MEMORANDUM

SUBJECT: Response to 2nd Traffic Review
Proposed 40B Residential Development
274 Water Street, Pembroke, Massachusetts

Conceptual Improvement Plan
Church Street at Water Street

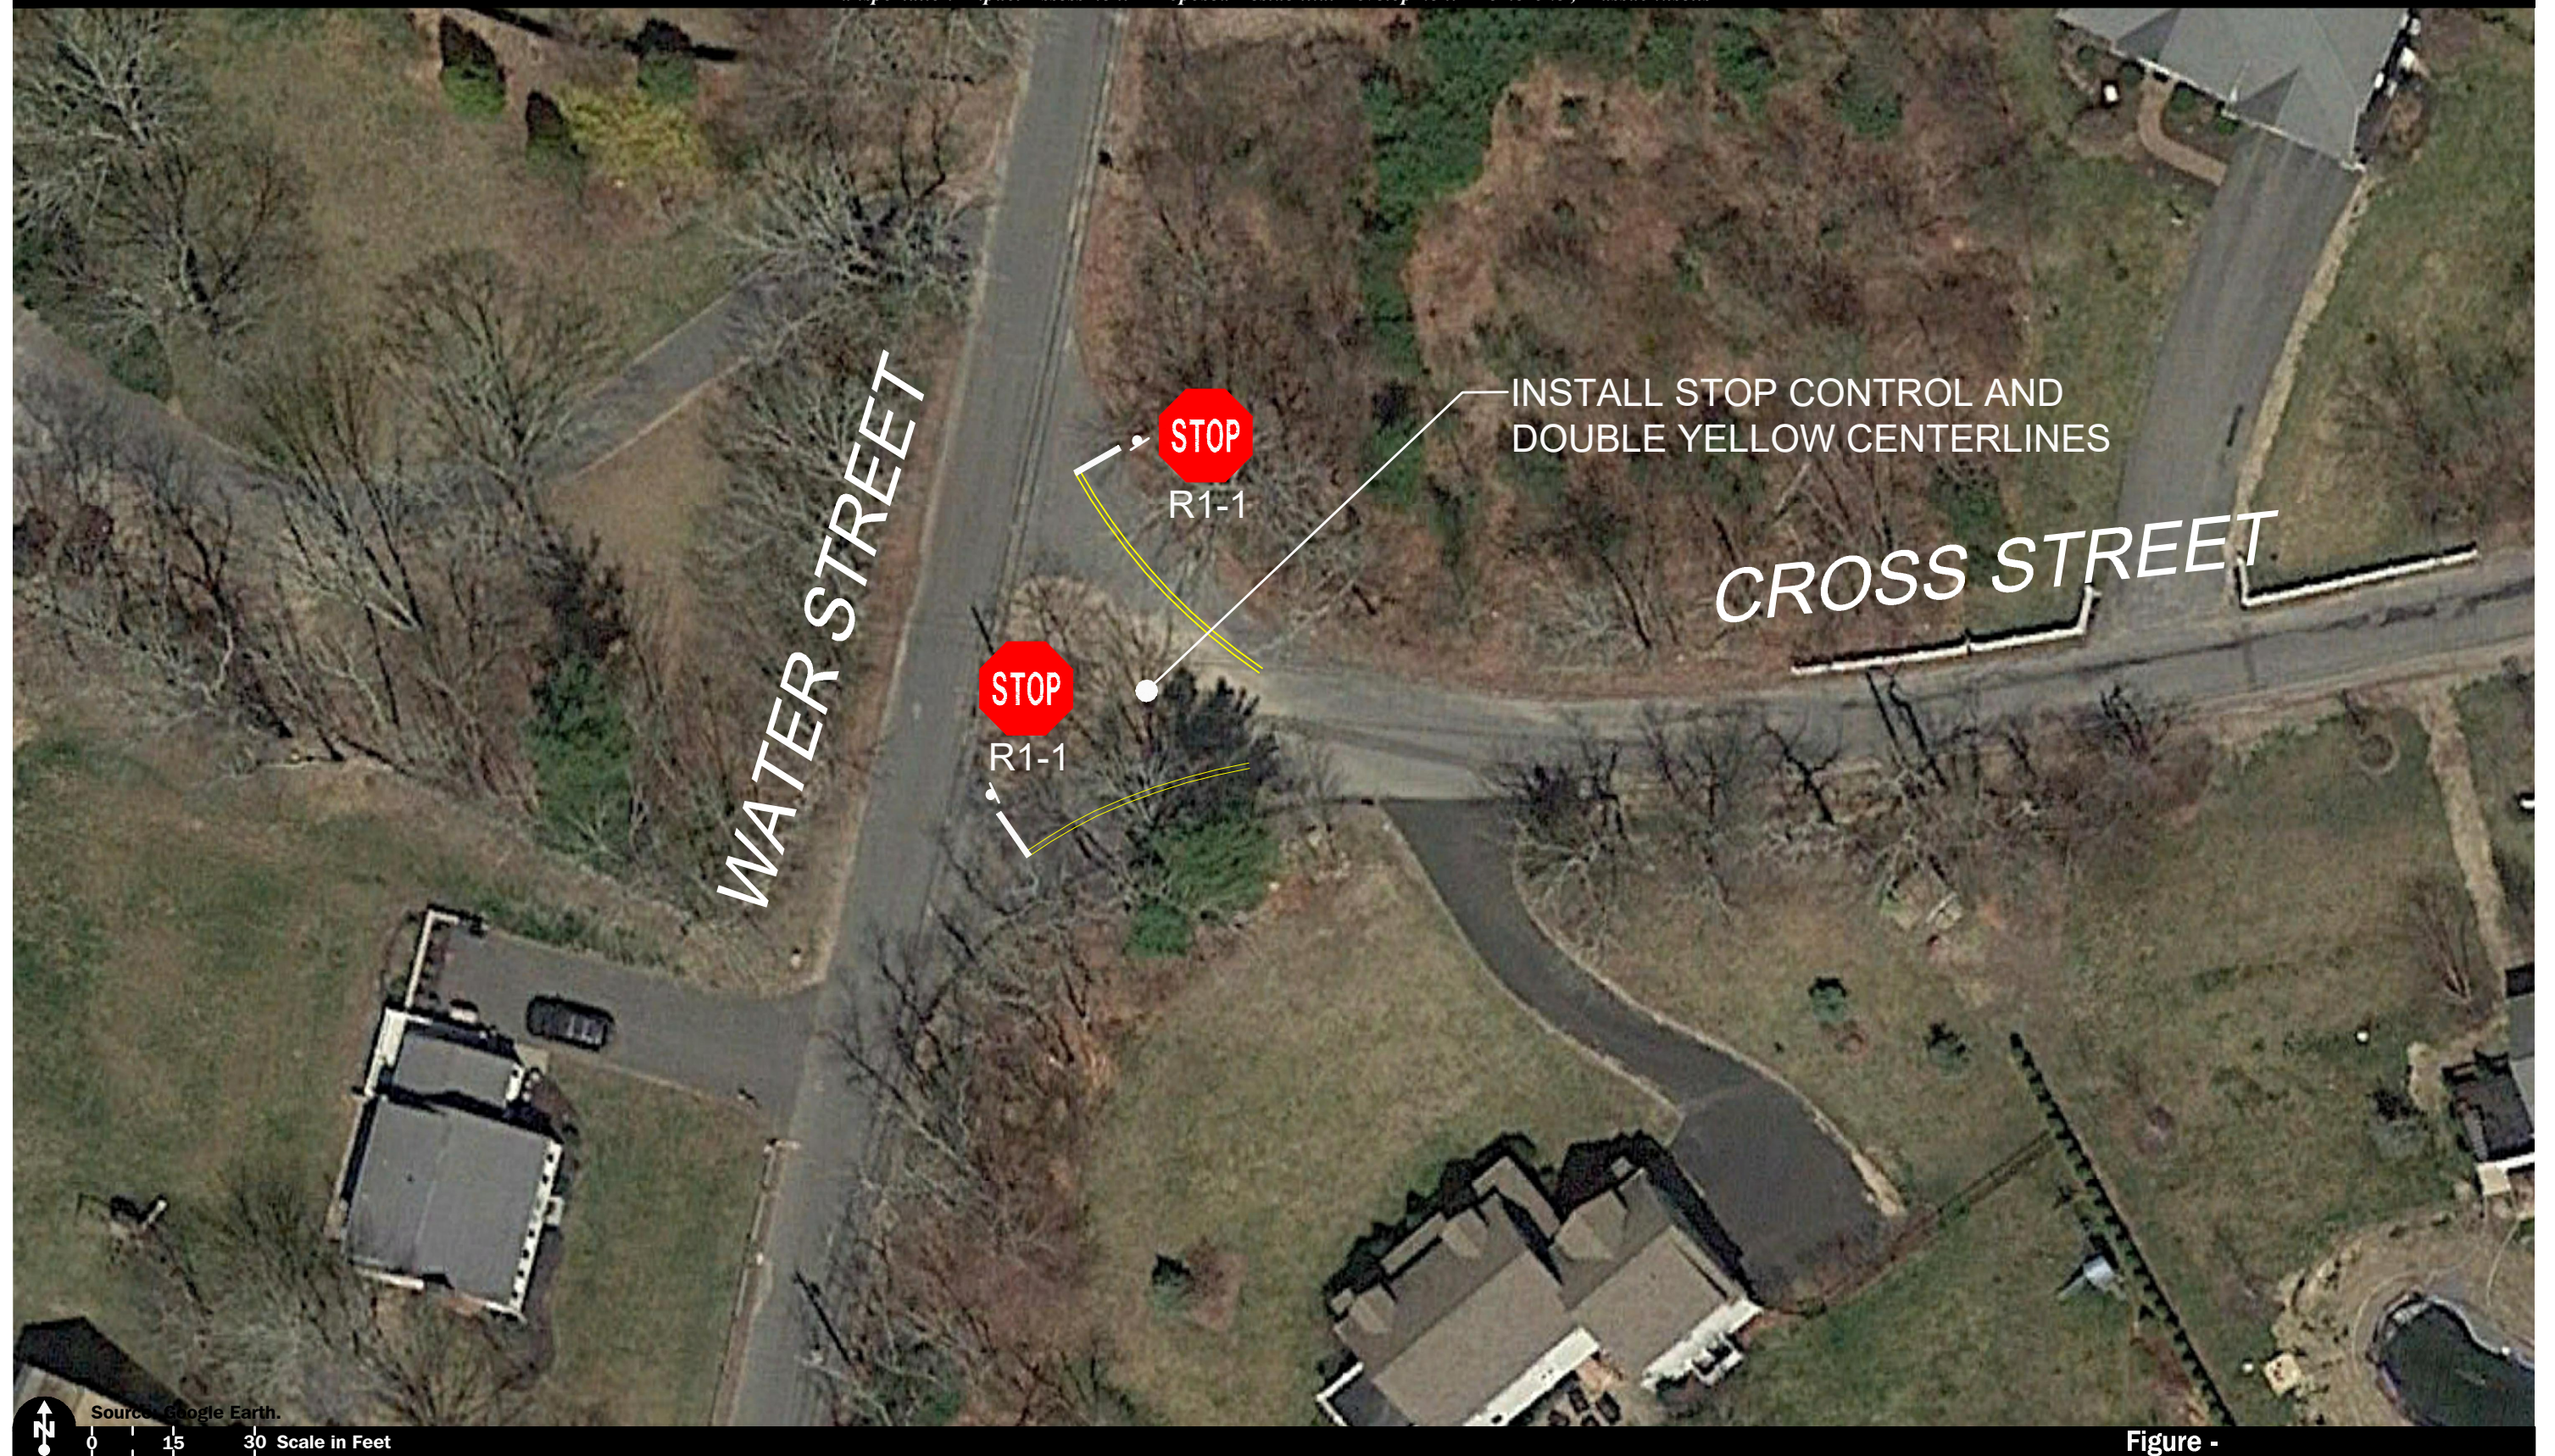
Comment 15: “Based on the above commitments, **we recommend the applicant submit a conceptual plan showing the recommended improvements for review, including how Water Street will be realigned, what signs are proposed, and where vegetation and roadside fixtures will be trimmed and/or removed.** Without such a plan, the specific actions proposed and limits of work cannot be ascertained. If MassDOT approval for these improvements is required, then the applicant should submit the necessary permit application to MassDOT. MassDOT is not likely to deny a request for improvements to their streets.”

Response: As requested by RMA, a conceptual improvement plan for the intersection of Church Street with Water Street is included as an attachment to this document. Proposed improvements, which are subject to MassDOT review and approval, include the installation of new pavement markings to better delineate inbound and outbound turning paths for vehicles turning to and from Water Street, as well as the provision of a short left-turn pocket for vehicles turning left onto Church Street, that will allow right-turning vehicles to bypass on the right. All new pavement markings and signage will be installed in accordance with *Manual on Uniform Traffic Devices* (MUTCD)³ design criteria. The applicant is also committed to cutting back existing vegetation within the Town of Pembroke and MassDOT right-of-way, north of the intersection, to improve sight lines in this direction.
